CORRECTION OF SERVICE MANUAL

No.: SCH04020-A 1/6

Please correct your service manual

Please add the contents and substitute the new pages attached after this page for the pages of each service manual as follows.

Refer to RRV2906 page:103

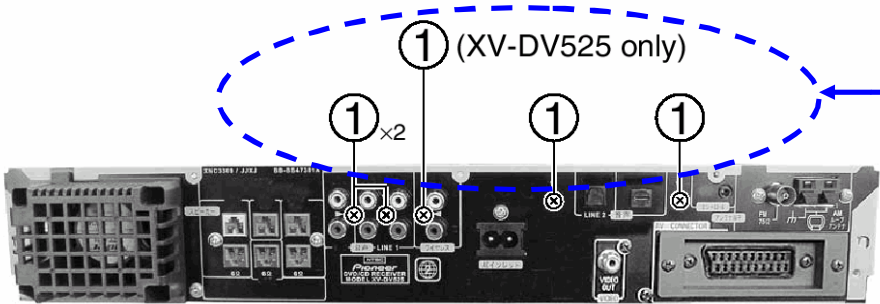
<1>Please add the following contents.

Make sure to tighten these screws when assemble the unit because the DSP assy on the CONTROL assy gets the GND from the rear panel.

① Remove the five screws. (for XV-DV525)
Remove the four screws. (for XV-DV424 and XV-DV323)

Refer to RRV2946 page:102

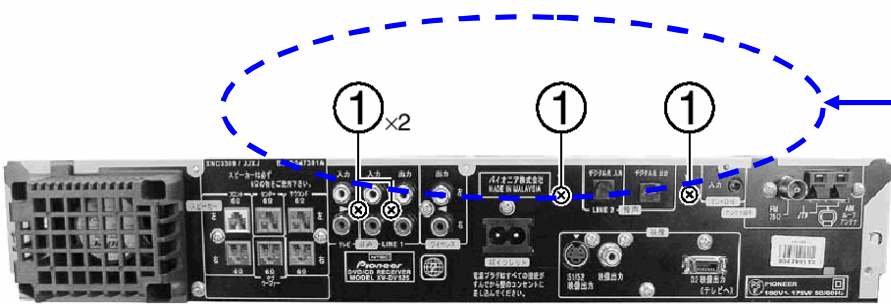
① Remove the four screws.

Refer to RRV2772 page 118.

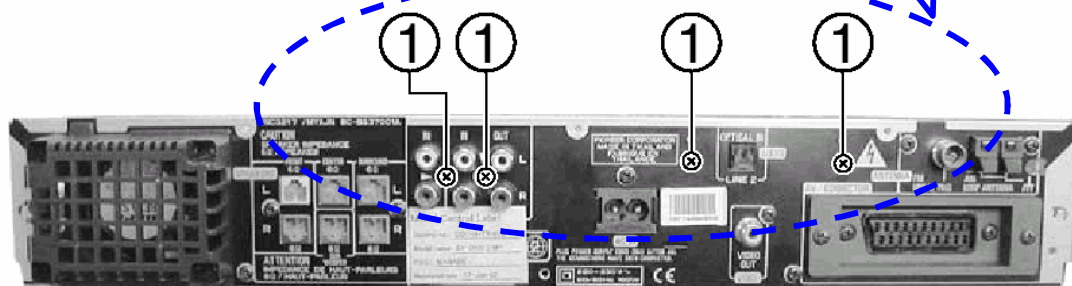
<2>Please add the following contents.

Make sure to tighten these screws when assemble the unit because the DSP assy on the CONTROL assy gets the GND from the rear panel.

- 1 Remove the four screws for XV-DV313.
Remove the five screws for XV-DV515.
(One screw is added for the wireless terminal.)

<4>Please substitute this page for RRV2906 page 104 and RRV2946 page 103.

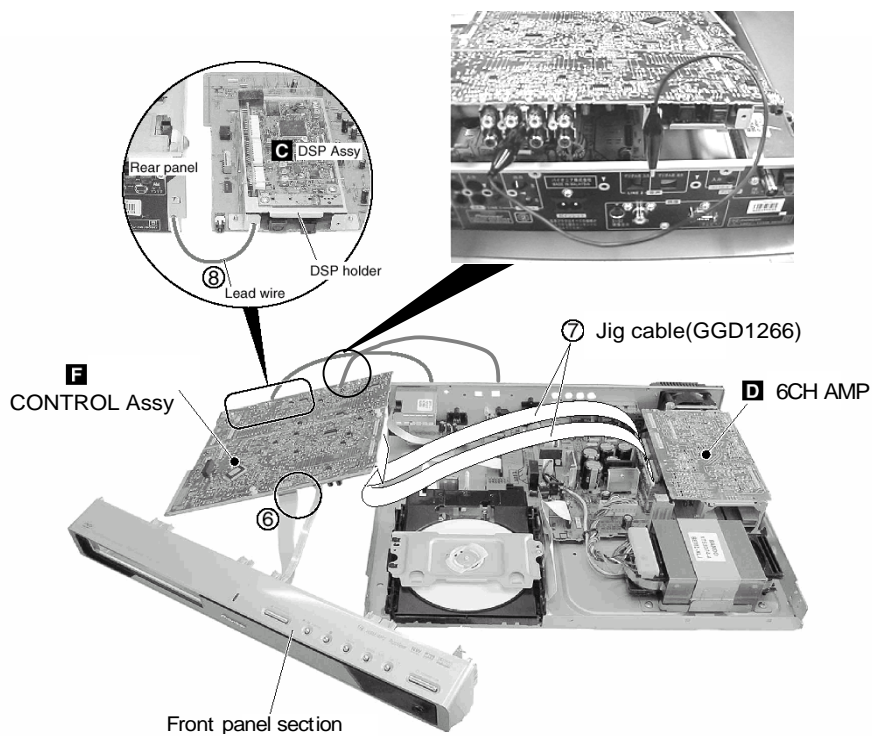
- 6) Reattach the front panel section.
- 7) Connect the jig cable.
- 8) Connect the following parts to the chassis
 - #DSP Holder
 - #Audio Terminal GND

Caution;

If the Power is turned on when the DSP Holder (DSP GND) and the Audio Terminal GND are not connected to the rear panel (chassis), the protection, "PRTCT ERR" works blinking the TIMER LED on the FL display and the parts below may be destroyed at the DSP ASSY.

Release the protection detection entering the "Service Test Mode".

IC8702 : TC74VHCT244AFT

IC8401 : AK4529VQ

R8415 : 4.7O

If the above parts are destroyed, the audio signal can not be out.

Please refer to RRV 2906 page 105 and RRV 2946 page 104.

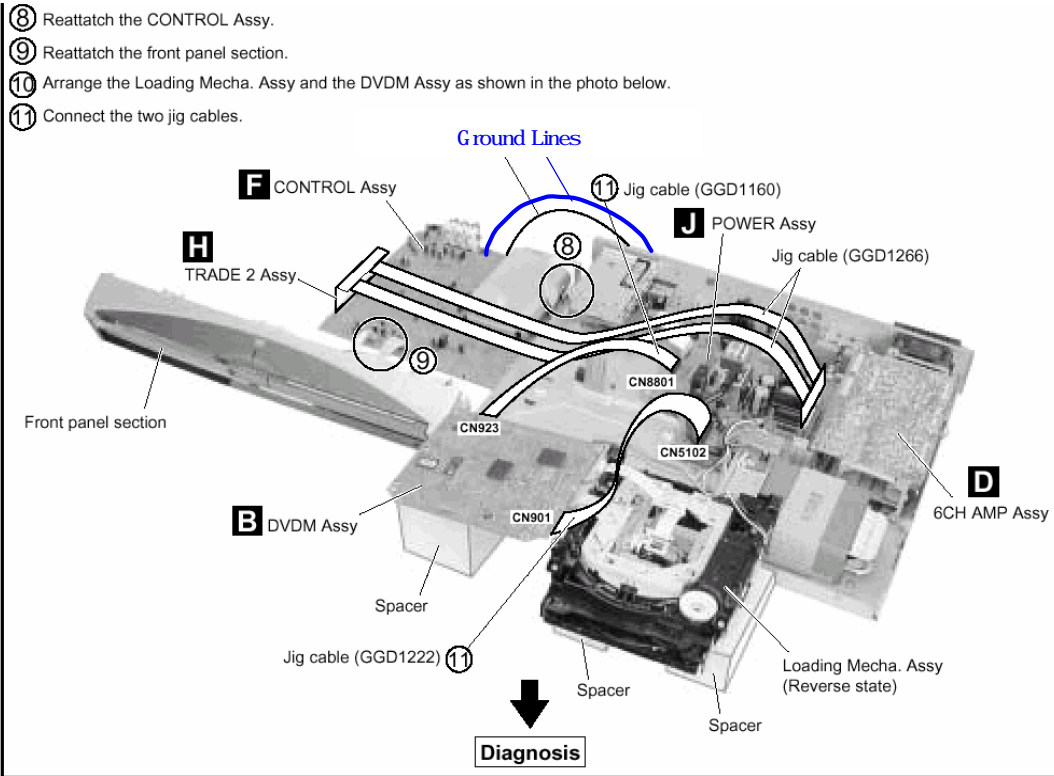
<5>Please add the following contents and lines.
